TB 10-8145-222-23

**TECHNICAL BULLETIN
FOR
REPLACEMENT OF REFRIGERATION SYSTEM ON MULTI-TEMPERATURE
REFRIGERATED CONTAINER SYSTEM (MTRCS)
NSN 8145-01-534-3597**

**HEADQUARTERS, DEPARTMENT OF THE ARMY
1 DECEMBER 2013**

Figure 2. Battery Cables.

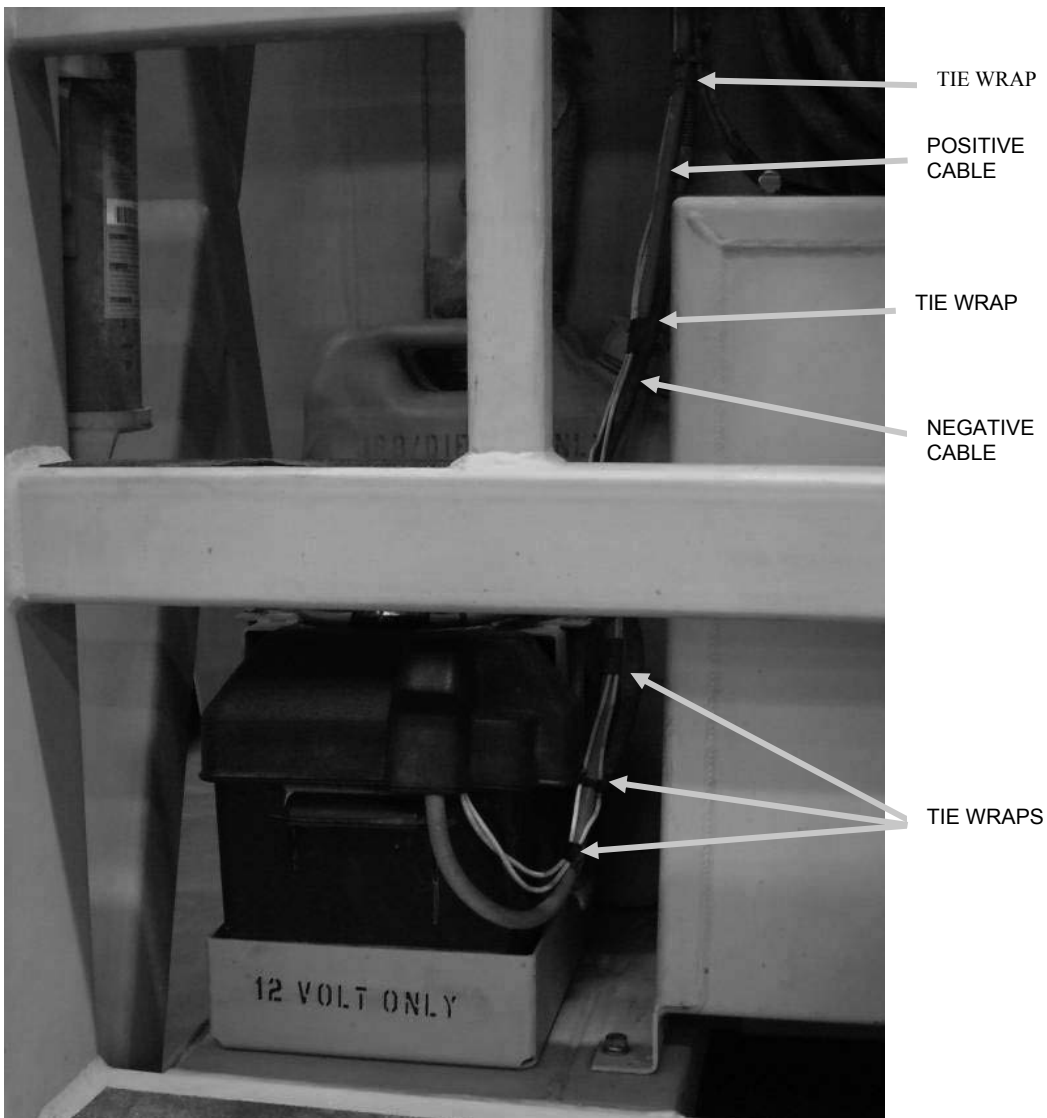
- (1) Refer to TM 10-8145-222-13, WP 0075, and remove RU.
- (2) Cut tie wraps and tape, and remove positive (red) and negative (black) battery cables (Figure 2) from MTRCS. Discard cables.

Figure 4. Capacitor Box Removal.

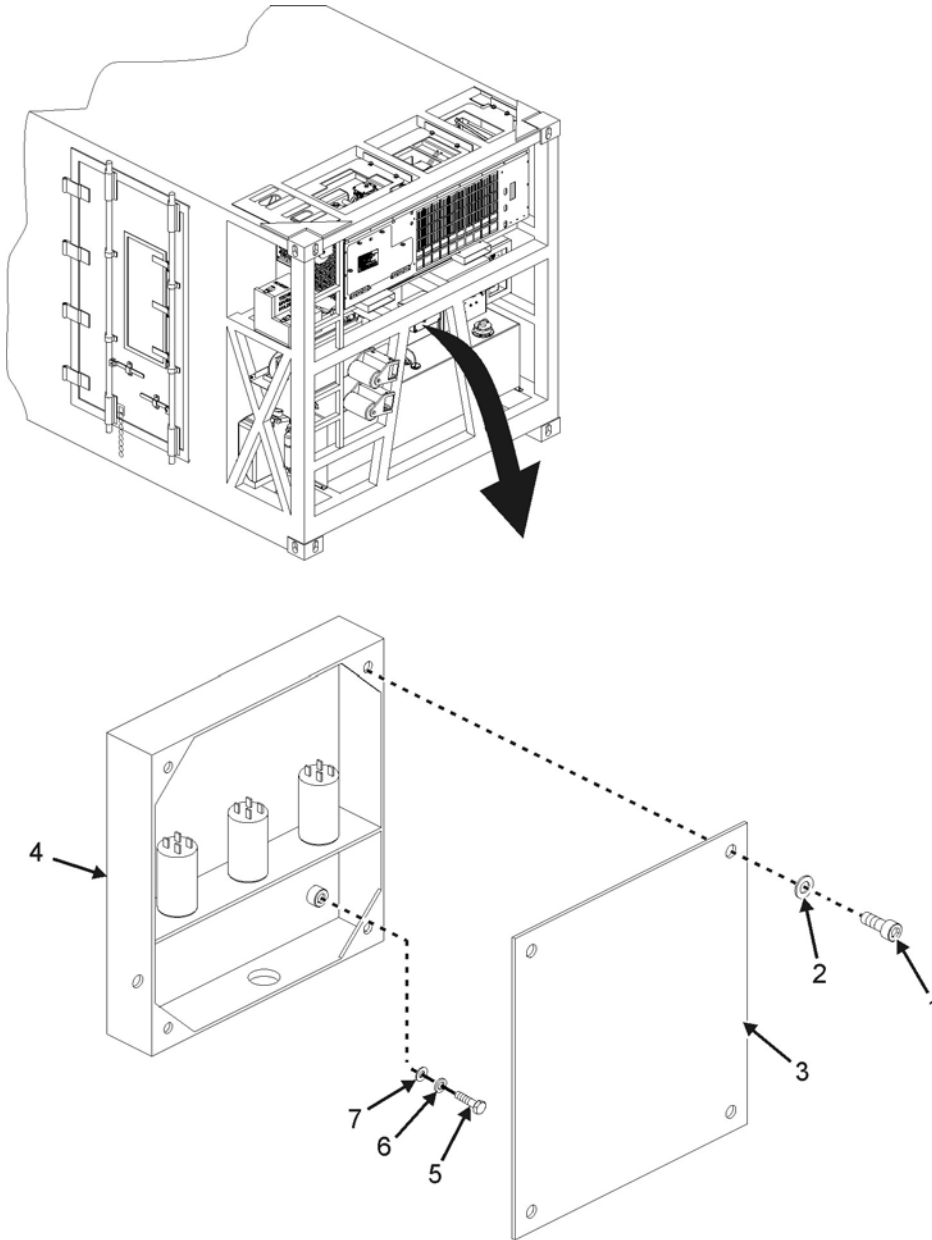
- (a) Remove four bolts (Figure 4, Item 1), washers (Figure 4, Item 2), and cover (Figure 4, Item 3) from capacitor box (Figure 4, Item 4).
- (b) Discharge capacitors with shorting probe.
- (c) Remove four bolts (Figure 4, Item 5), lock washers (Figure 4, Item 6), washers (Figure 4, Item 7), and capacitor box (Figure 4, Item 4) from MTRCS. Discard capacitor box and hardware.
- (d) Install four 15795-814 washers (Figure 4, Item 7), four 92148A210 lock washers (Figure 4, Item 6) and four 91287A167 screws (Figure 4, Item 5) into mounting holes in MTRCS.

Figure 7. J13 Cable Removal.

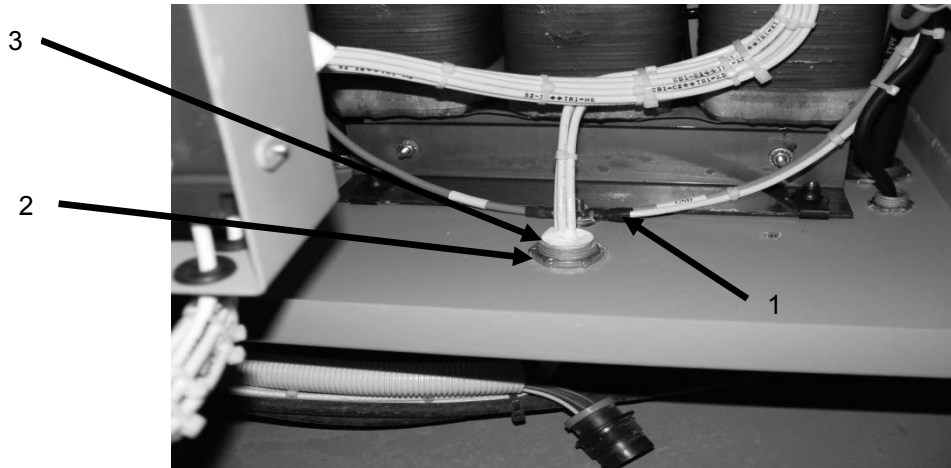
- (7) Remove TR1-X0 wire (Figure 7, Item 1) from ground lug terminal at bottom of power box.
- (8) Note locations of wire ties for J-13 wires (including ground wire). Remove wire ties.
- (9) Completely loosen conduit locknut (Figure 7, Item 2) from strain relief bushing (Figure 7, Item 3) for the J-13 cable. Pull strain relief (with J-13 wires) out of power box.

Figure 8. Power Input Box K1 Relay Removal.

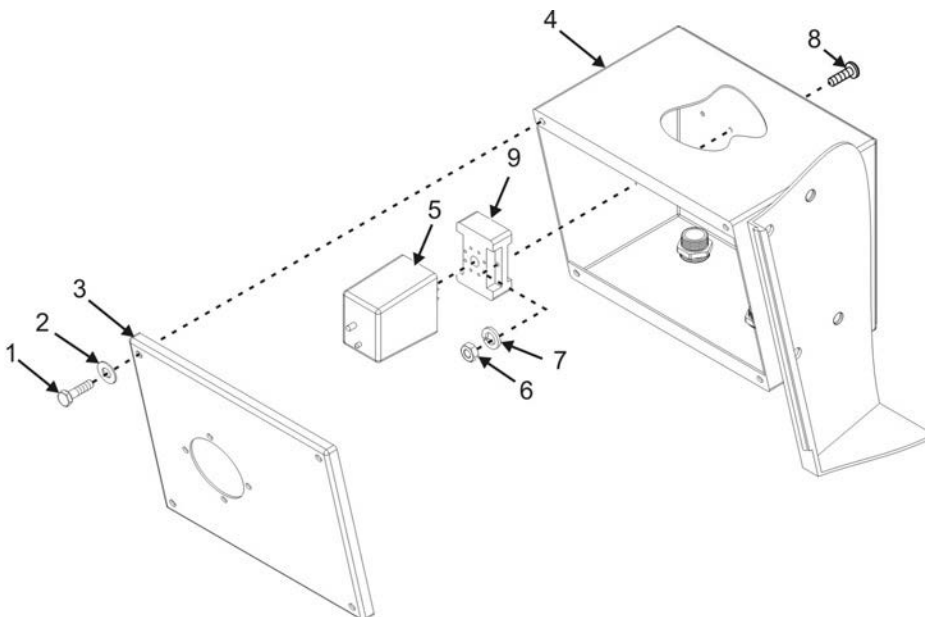
- (10) On the power input box, remove four screws (Figure 8, Item 1), four washers (Figure 8, Item 2), and cover (Figure 8, Item 3) from power input box (Figure 8, Item 4).

- (12) Remove power input box, J9, and J13 cables (with strain relief).
- (13) Unplug K1 relay (Figure 8, Item 5); and remove two nuts (Figure 8, Item 6), two lock washers (Figure 8, Item 7), two screws (Figure 8, Item 8), and relay socket (Figure 8, Item 9) from electrical box (Figure 8, Item 4). Retain hardware for installation.
- (14) Disconnect J9 cable wires from relay socket (leave jumper wire between K1-1 and K1-2 installed). Retain relay and socket for installation into power box. Discard electrical box, J9 and J13 cables (with strain relief).
- (15) In the power box, plug four power input box mounting holes with four MS35307-360 bolts, four MS15795-814 washers (Figure 9, Item 3), four MS35338-141 lock washers (Figure 9, Item 2), and four MS35649-2384 nuts (Figure 9, Item 1).

Figure 9. Power Input Box Removal.

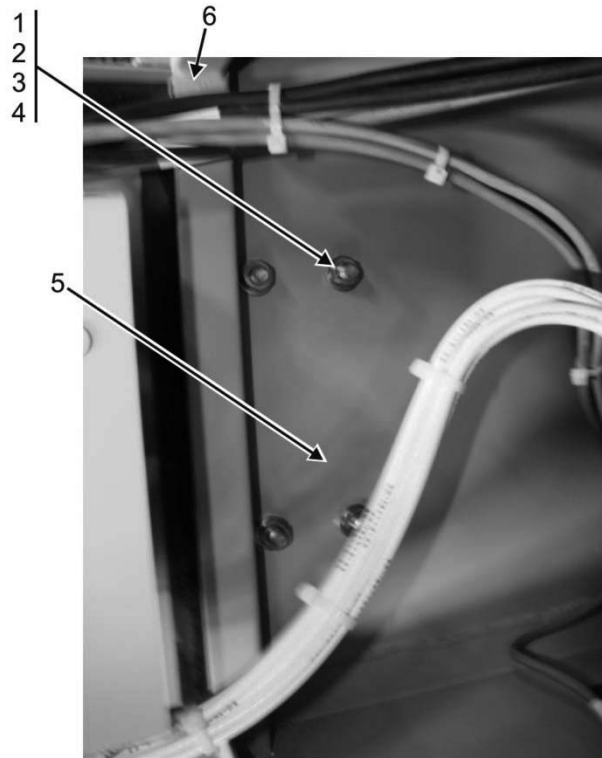
- (11) Remove four nuts (Figure 9, Item 1), four lock washers (Figure 9, Item 2), four washers (Figure 9, Item 3), and four rubber washers (Figure 9, Item 4) securing power input box (Figure 9, Item 5) to power box (Figure 9, Item 6). Discard hardware.

Figure 10. S7 Toggle Switch Removal.

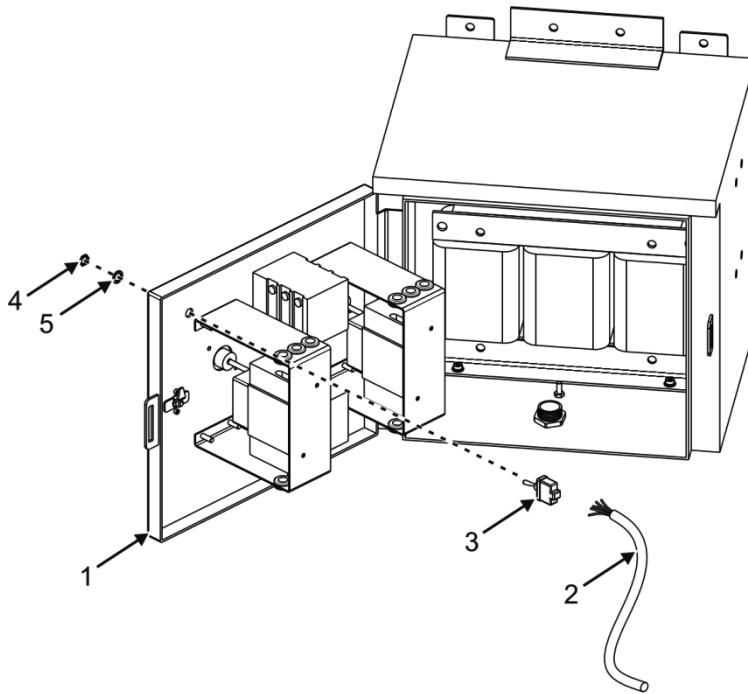
- (16) On the power box door (Figure 10, Item 1), tag and disconnect wiring (Figure 10, Item 2) to toggle switch (Figure 10, Item 3).

- (17) Remove nut (Figure 10, Item 4) and washer (Figure 10, Item 5) securing toggle switch (Figure 10, Item 3) to power box door (Figure 10, Item 1).
- (18) Remove toggle switch (Figure 10, Item 3).
- (19) Plug hole in power box with 9688K125 plug. Discard switch.

Figure 11. J-11 Cable Removal.

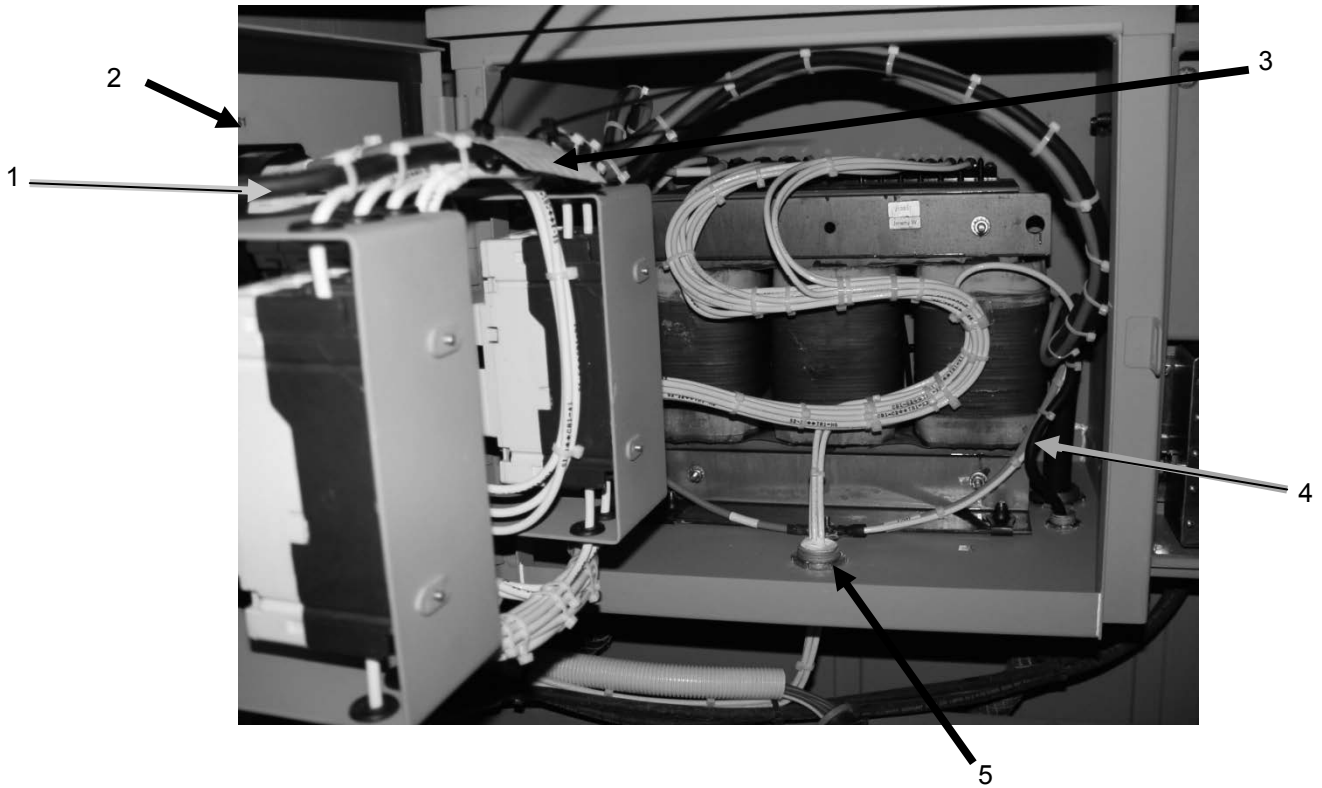
- (20) Cut and discard J11 cable (Figure 11, Item 1) near the wire tie closest to the switch (Figure 11, Item 2). Cut other end of cable near wire tie closest to the bottom of the box (Figure 11, Item 4). Pull remaining J11 cable from strain relief at bottom of power box. Remove strain relief from power box. Discard strain relief, cable, and P11 plug. Attach 182K1670 cable tag (Figure 11, Item 3) using two MS3367-2-9 tie wraps.

Figure 12. K1 Relay Locating Tool.

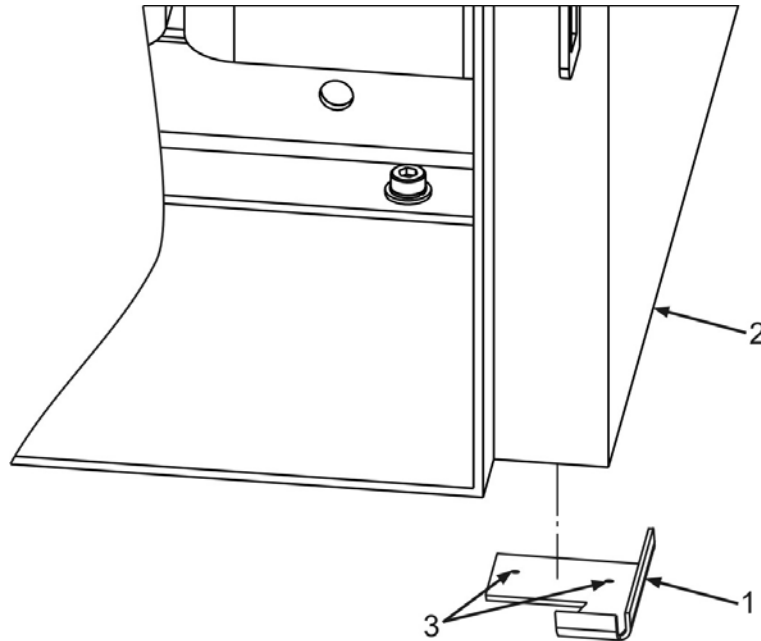
- (a) Position 182K1671 locating tool (Figure 12, Item 1) underneath lower right corner of the power box (Figure 12, Item 2).

- (b) Use locating tool as a template to mark the location of the relay socket two mounting holes (Figure 12, Item 3), one for each side of the socket.

- (c) Drill two 11/64-inch holes through the power box. Remove filings.
- (d) Position K1 relay socket (Figure 13, Item 1) in the lower, right corner of the power box (Figure 13, Item 2), with key in socket facing forward, as shown in Figure 13.

Figure 14. Strain Relief Installation.

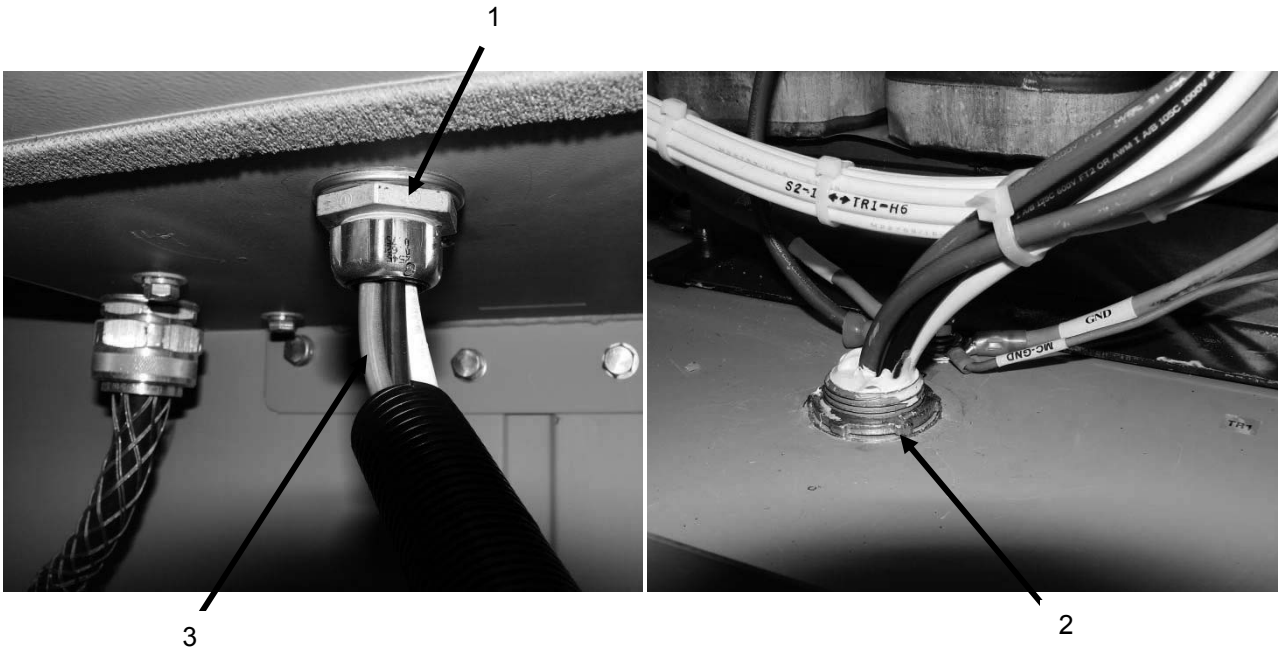
- (2) Install replacement 5054519-13 strain relief bushing (Figure 14, Item 1) with 13211E8321-3 o-ring, into hole in bottom of power box. Install nut (Figure 14, Item 2) onto bushing. Route new 182K1016-1 J13 cable (Figure 14, Item 3) up through strain relief, in bottom of power box.

Figure 15. Tape Location on Power Box.

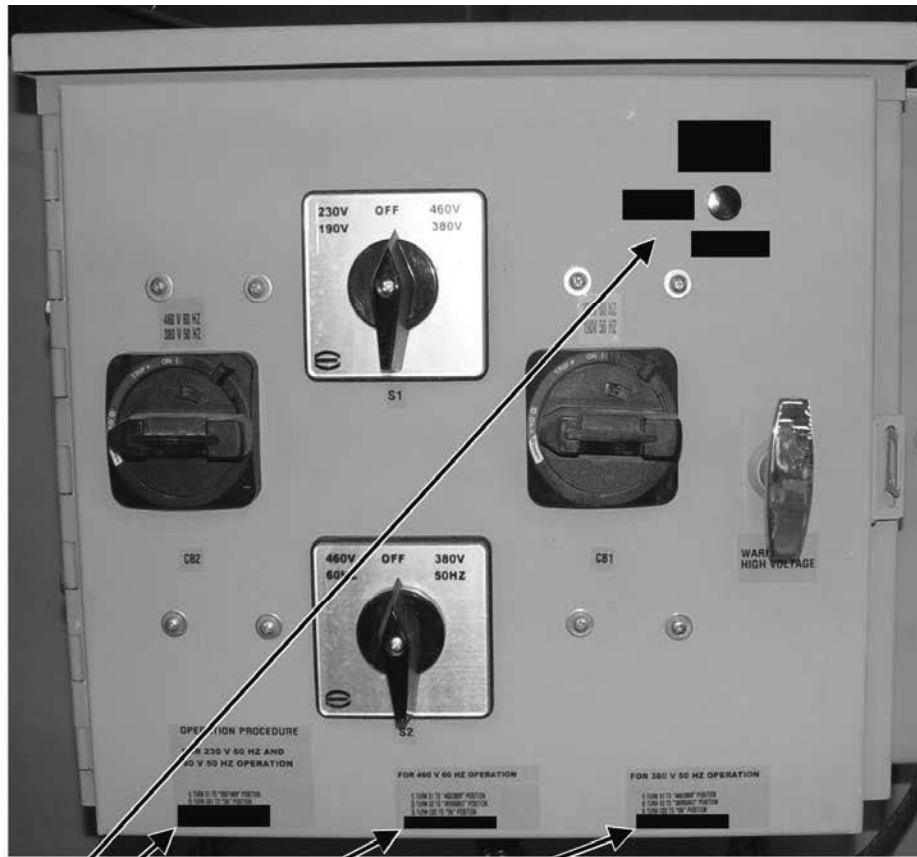
(9) Use black filament tape to cover "S7" references on power box door, as shown in Figure 15.
